Subject: ACCUMULATION OF WATER AND/OR SAND IN FUEL-FILLER LID BOX	Bulletin No.: 09-029/21
	Last Issued : 10/08/2021

2019-2021 Mazda3 (Japan built) vehicles with VINs lower than JM1BP*****330217 (produced before Jan. 6, 2021)

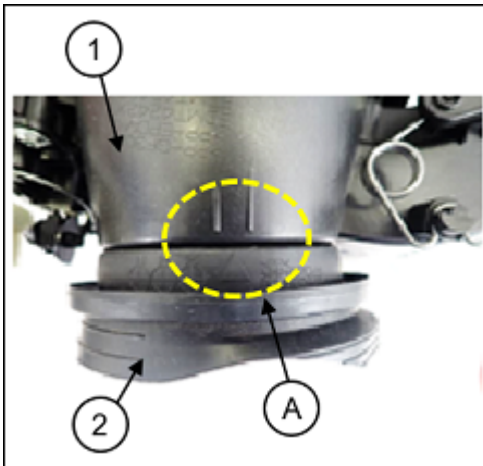
Since the drain hole on the dust cover is located in an improper position, water may not be able to completely drain which results in the accumulation of water and sand. To eliminate this concern, the dust cover (below) has been modified to drain the water more easily.

1. Verify the customer concern.
2. Replace the dust cover with a modified one according to the instructions on MGSS online FUEL-FILLER LID LOCK ACTUATOR REMOVAL/INSTALLATION.

- (1) Fuel-filler lid box
 (2) Dust cover

Detail of area "A" from the image above.

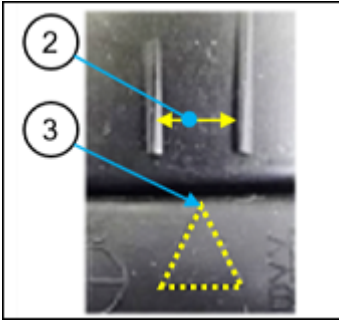
NOTE: Assemble the parts so that the top of the triangle (3) is located between the parallel lines (2).
